# CITY OF ALBUQUERQUE

PLANNING DEPARTMENT – Development Review Services

**RE: Paseo Del Norte Sports Complex (File: C17D008)**  
**Drainage Management Plan, Engineer's Stamp Date 11-4-2014**  
**Supplemental Calculations received 10-30-14**

DATE: NOVEMBER 3, 2014  
**DRAINAGE  
MANAGEMENT PLAN**

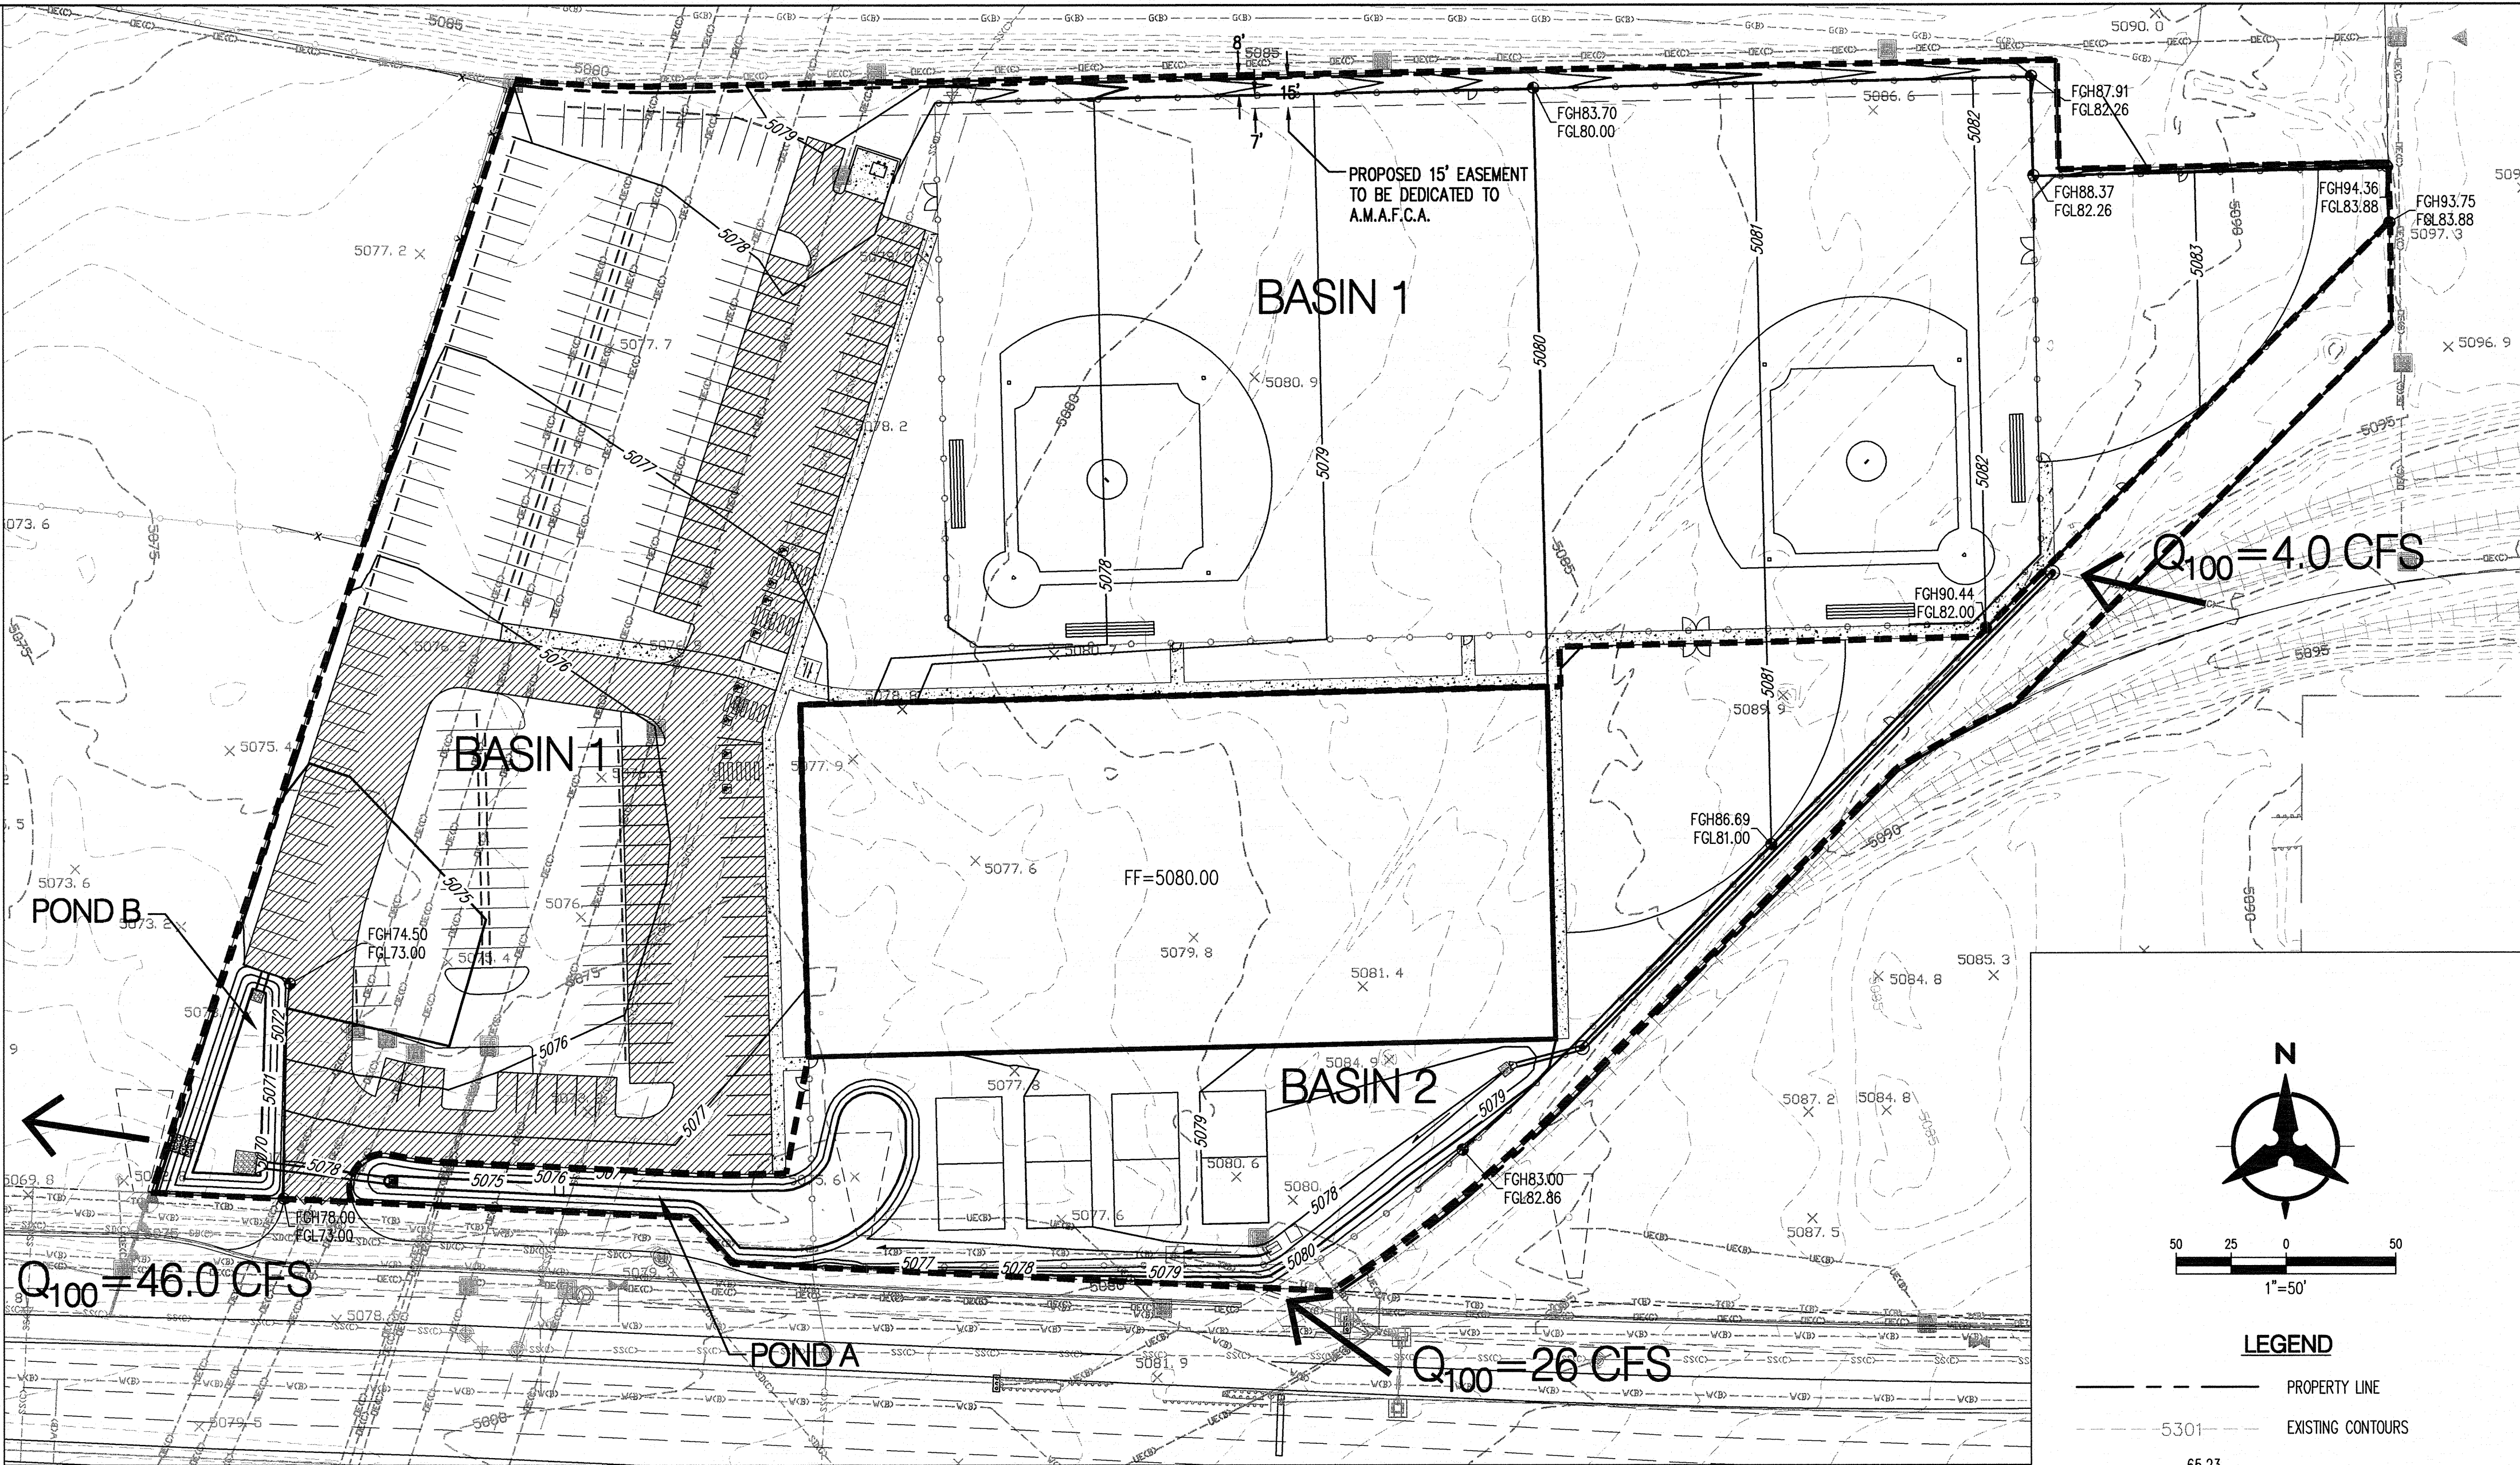
1. Show emergency overflow for Pond A.
2. Pond A needs to have 1' of freeboard
3. Detail rip-rap at Pond B (call out rock size and dimensions of rip-rap)
4. Show contours/spot elevations at waterblock
5. Flowline elevation along decel lane

## CONCEPTUAL GRADING PLAN

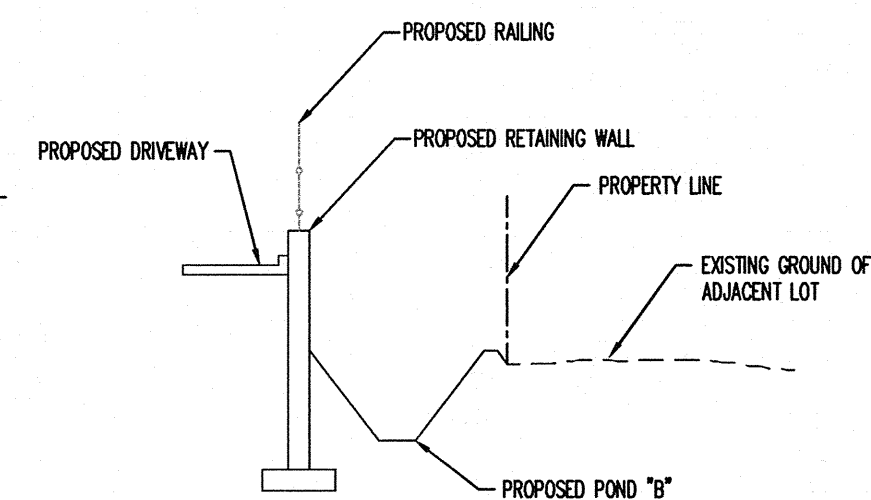
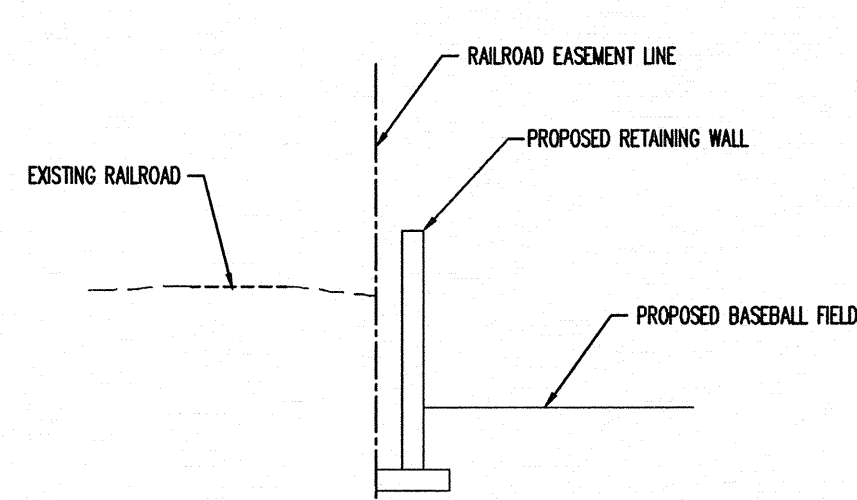
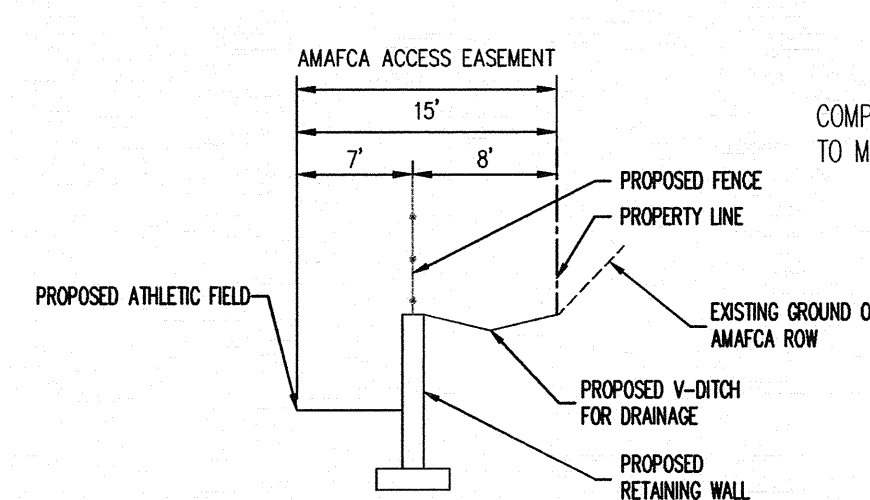
A few other comments you should take care of before you resubmit.  
The stormdrain should be moved out of the railroad easement.  
The billboard and sign are in the pond. The billboard foundation will be undermined by pond.  
The foundation for the sign? I would think it would have to be deeper piers. Both signs should have keyed notes indicating how you plan to handle these structures.

Rita: Matt is at a project meeting in Alamogordo today, so I'm revising the grading plan to address the additional comments below. An updated version will be sent to you later this morning. Please note however that the storm drain can stay within the railroad easement. This pipe is conveying flows from the rail easement. Furthermore the easement document specifically gives the right to the land owner to construct improvements such as this within the rail easement. I have attached that document for your review. Please note the underlined wording on the 3<sup>rd</sup> page of the attached PDF.

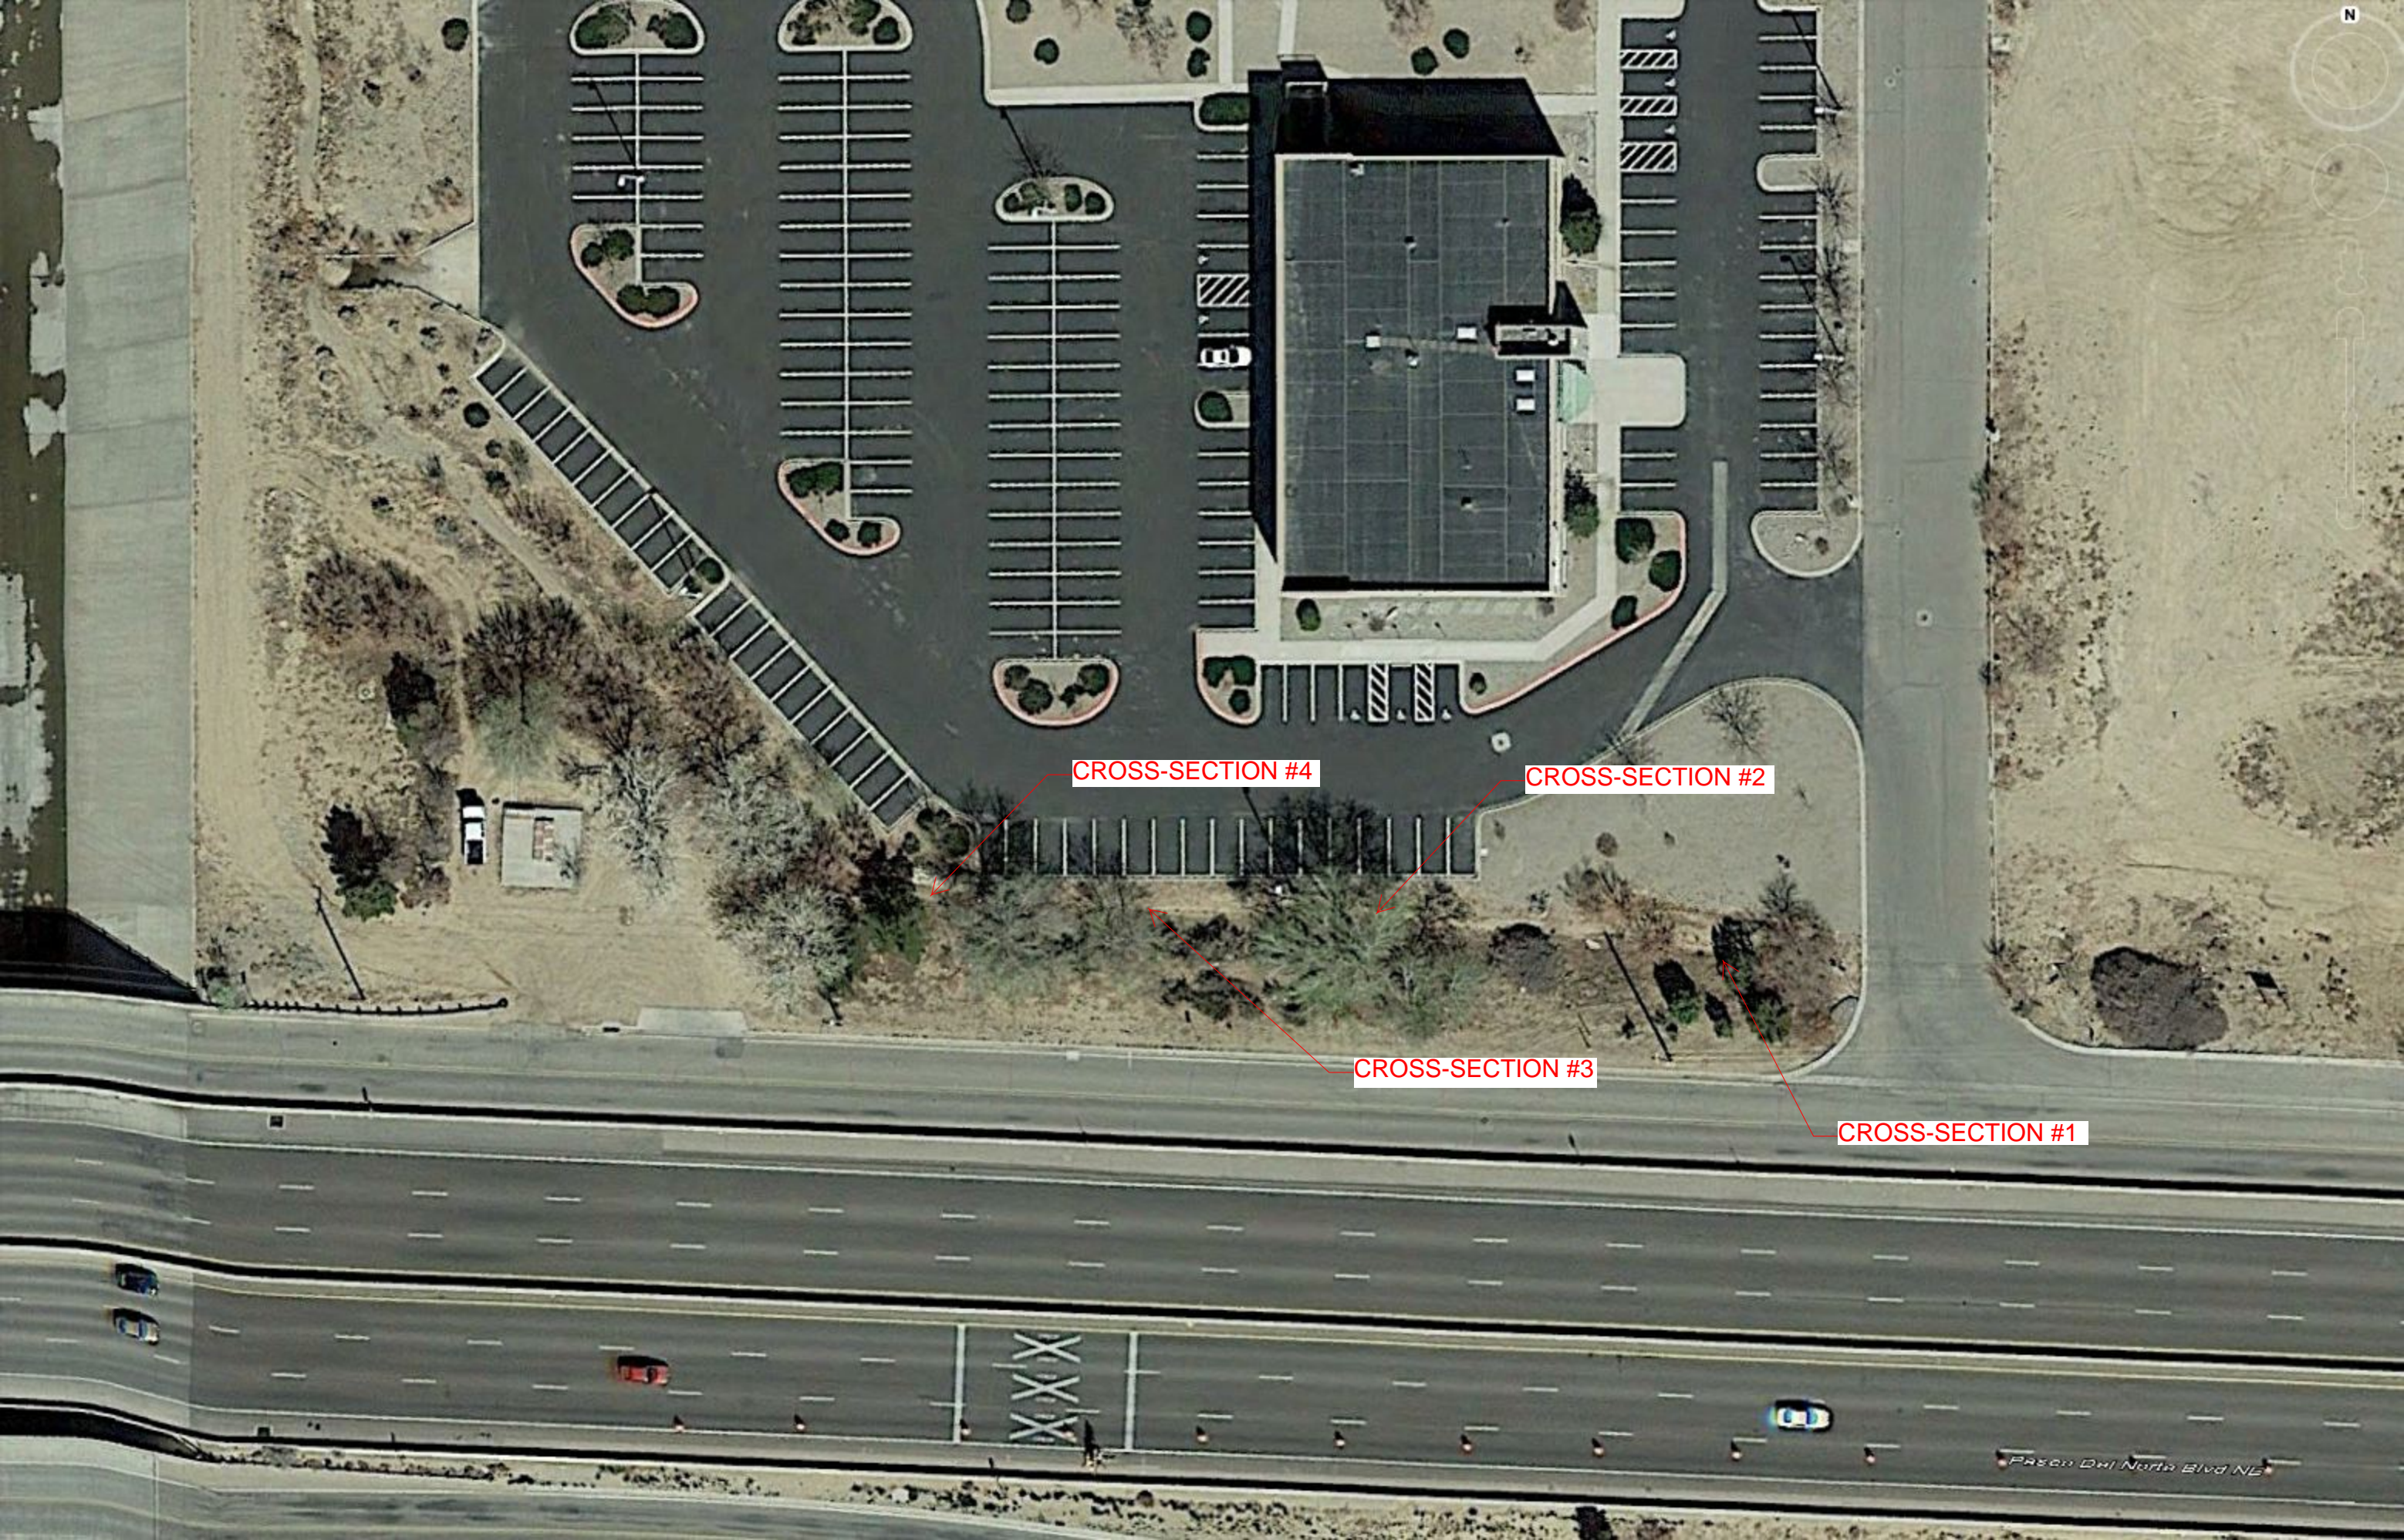
- **Downstream Swale Capacity:**
  - During the aforementioned meeting with AMAFCA and City Hydrology, a need to determine the capacity of the downstream swale was identified. Our site contributes 46 CFS to the swale. The property immediately west of our site contributes approximately 6.84 CFS per the previously mentioned approved drainage plan (C-17 / D019 Office Warehouse Dated 10/22/1997). Given this information, it was determined that the required capacity of the downstream swale is approximately 53 CFS.
  - During a site visit, we took measurements of several locations throughout the swale to determine a cross section. The slope of the swale is approximately 0.4%, this was determined using spot elevations provided on the topographic survey for the Paseo Del Norte / I-25 Interchange. Finally, using

**a Manning's value of 0.022, it was determined that the existing swale has enough capacity to accommodate the 53 CFS. Please see attached documents for calculations and cross-section locations.**
